**Agenda Item 3**  
**Lake – Woodbine Bridge**  
**Additions & Exterior Alterations**

## STAFF REPORT AND RECOMMENDATION

TO:	Chairman Grinnell and members of the Historic Preservation Commission
DATE:	March 16, 2022
FROM:	Catherine Czerniak, Director of the Community Development Department
SUBJECT:	<b>Lake – Woodbine Bridge – Demolition and Replacement</b>

## 5. Guardrail Options

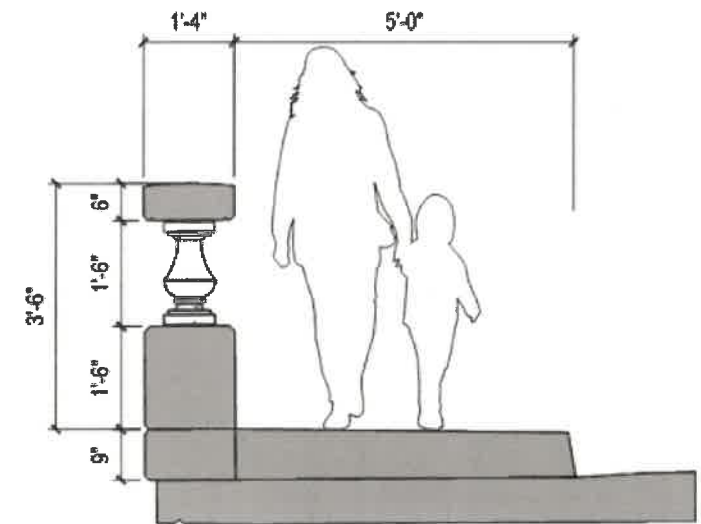
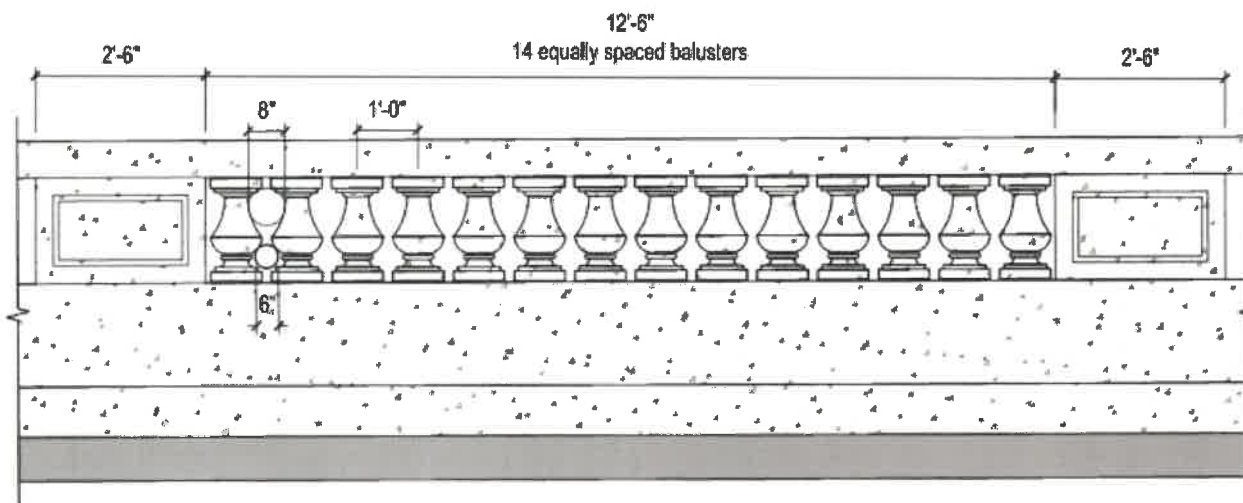
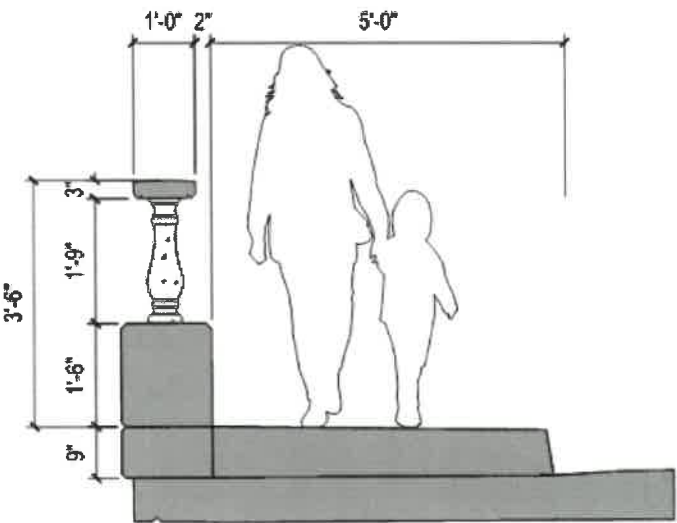
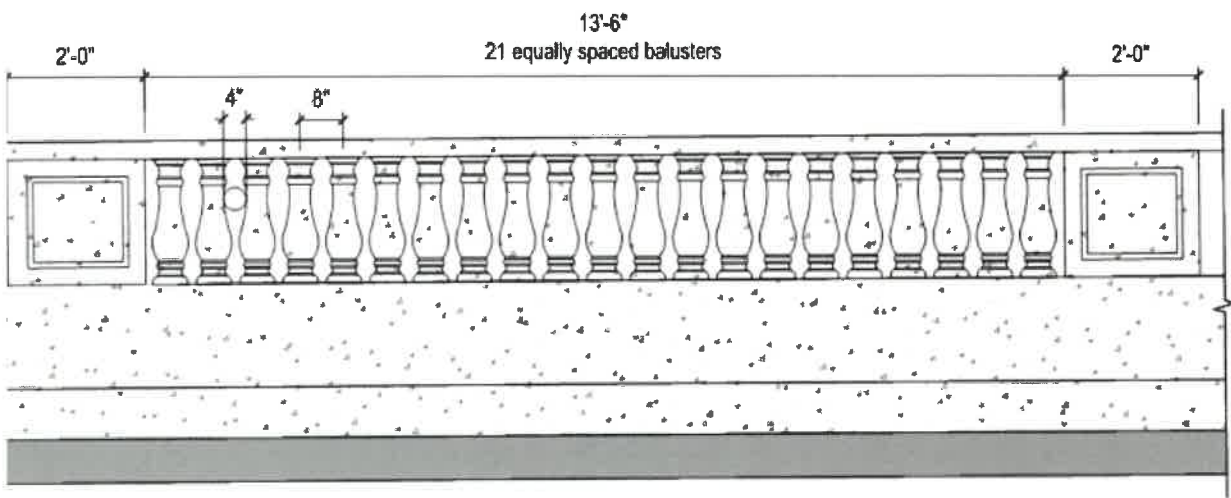
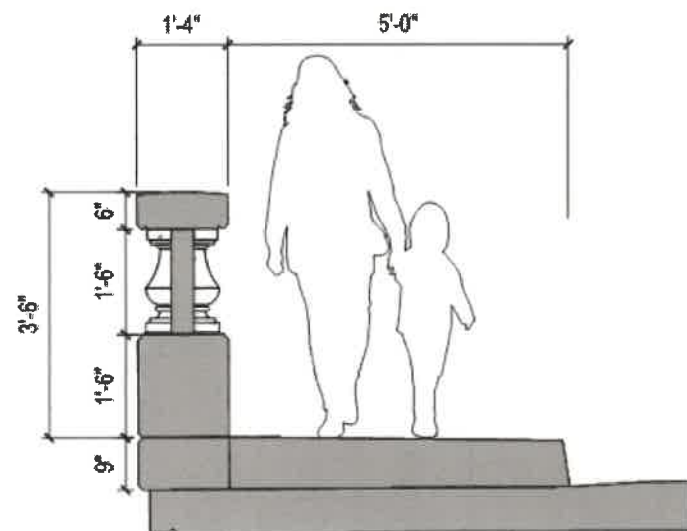
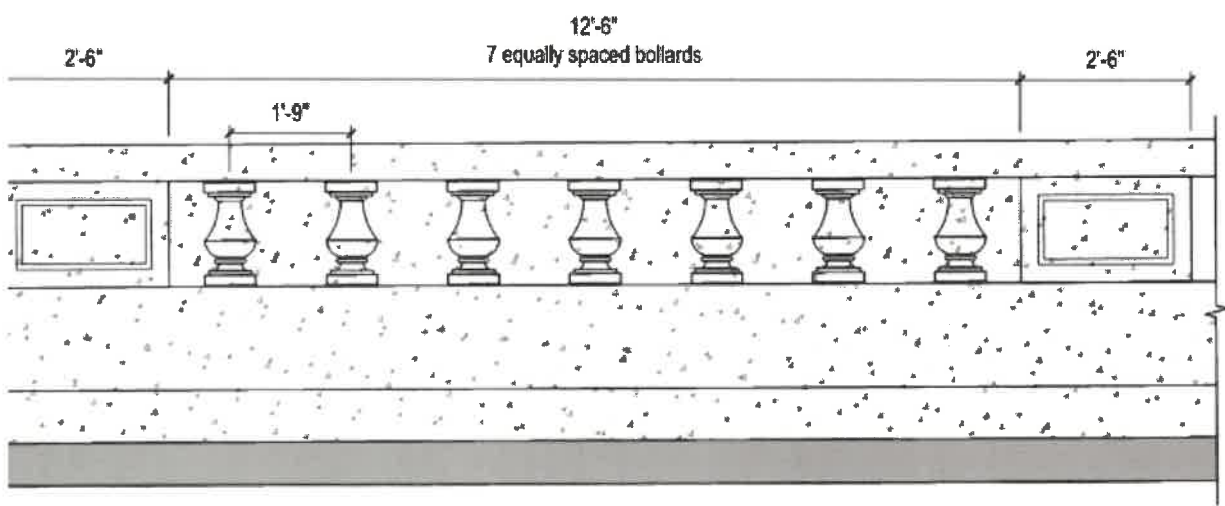
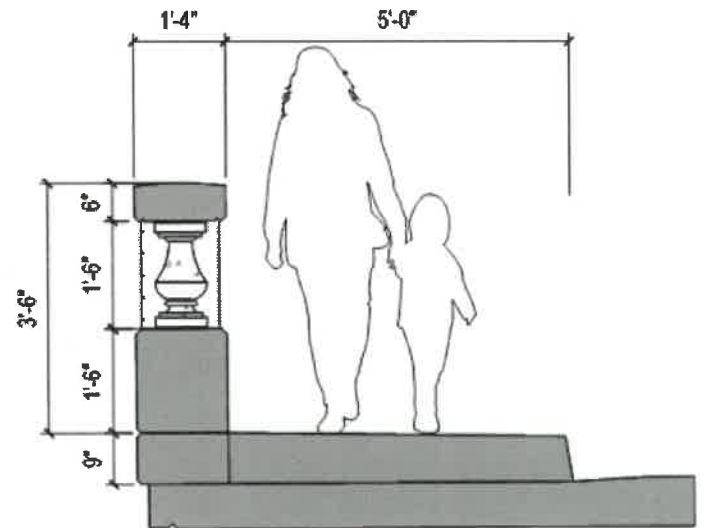
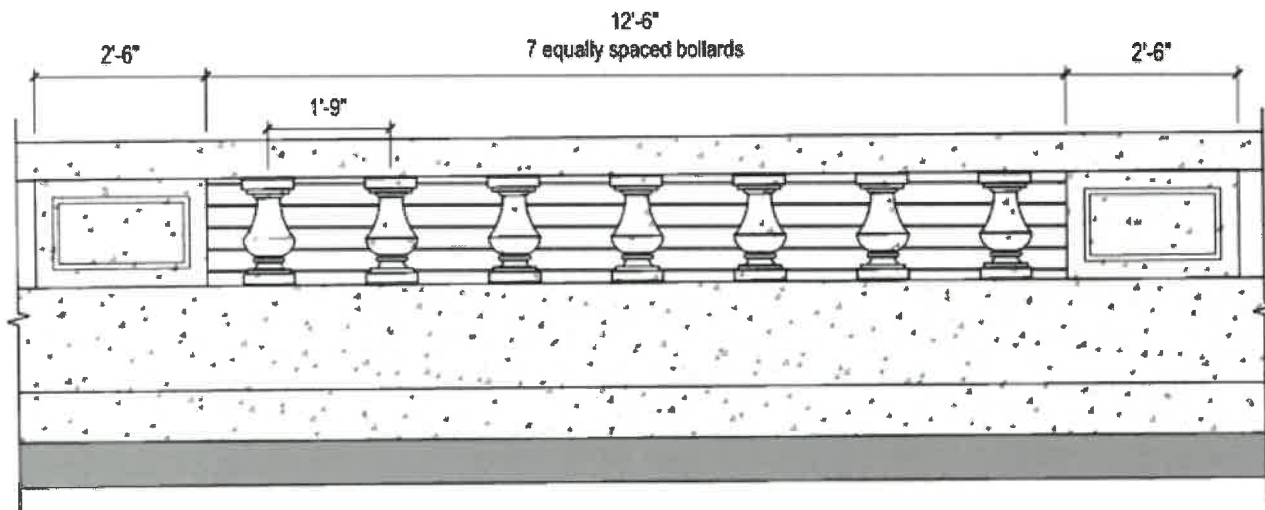
Question/Comment: Do you have side-by-side current and proposed, especially Option 1? Option 1 balusters look squashed under too-thick rail. Why must rail be so heavy but let's look at this one more closely. Option 2 are bowling pins. Option 3 – no. Option 4 – no thanks.

Response: We're in agreement on 2, 3 and 4 being undesirable. As previous stated in presentation, the top of the rail needs to be thick enough to be hold the railing together.

# Bridge Option 2: Open-Spandrel without Pedestals

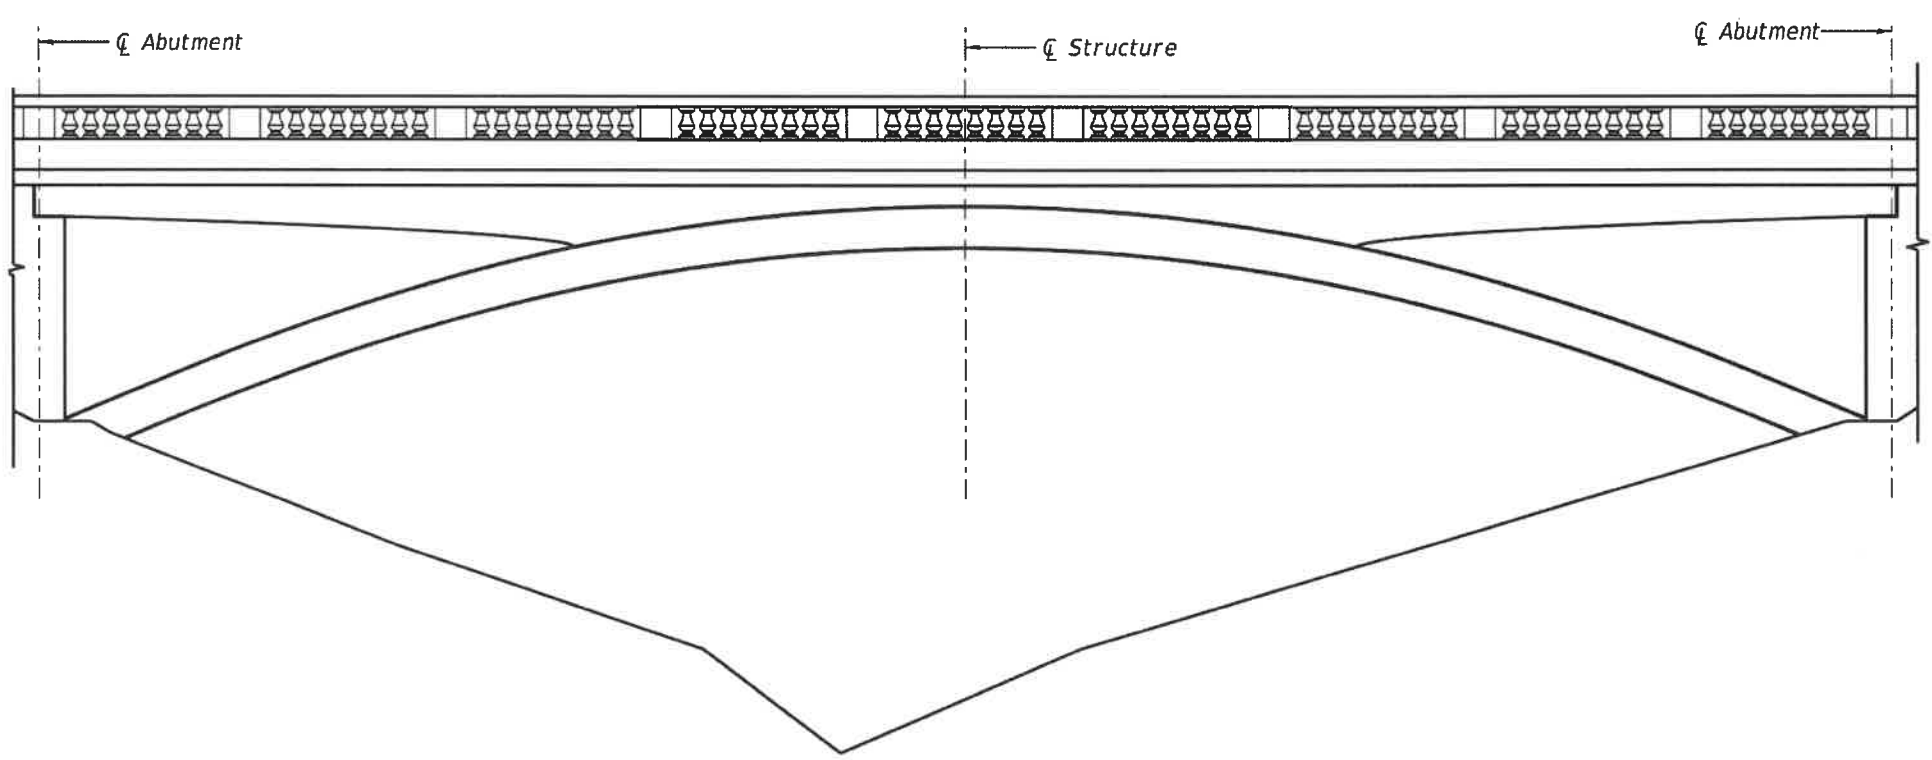
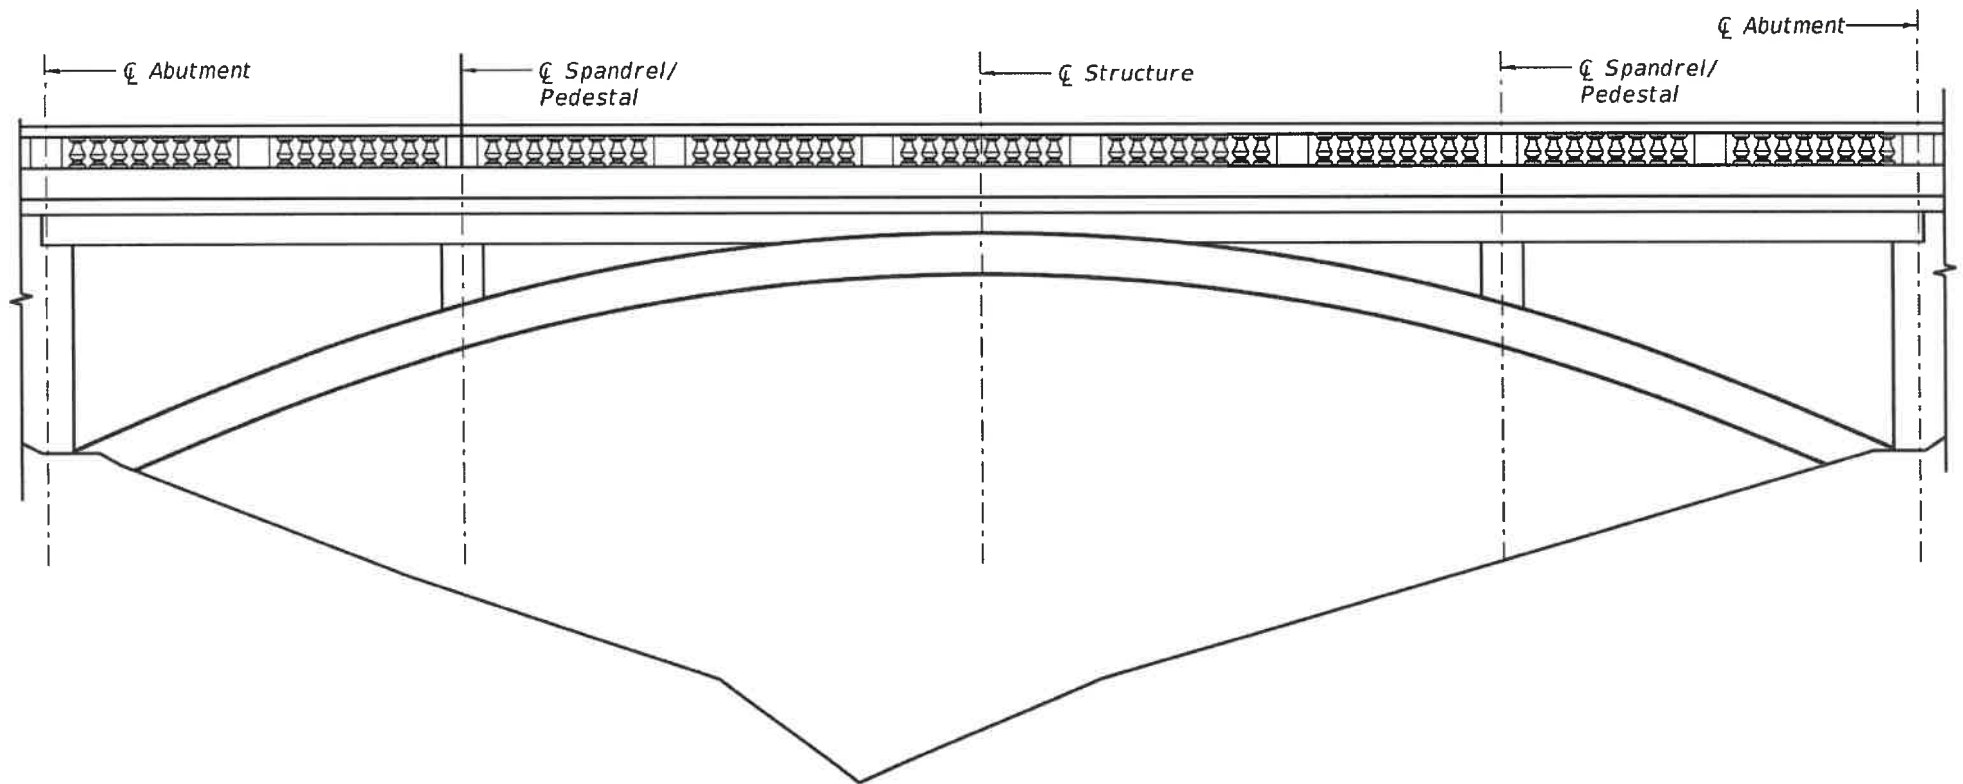
Question/Comment: Are the pedestals shown on the open-spandrel option columns or walls that extend from side to side?

Question/Comment: Bridge Options 1 and 2: Where is the 2-3-2 pattern?? Option 3 is 2-5-2. Why did you switch from historic original? Is the area above the arch and under the deck a solid wall or is it open

Response: They are walls that extend the width of the arch.

Response: The span arrangement is being adjusted. We start with openness and continue until we hit a resolution point. The arrangement of balusters may change but the rules stay the same. The area above the arch and under the deck is open.
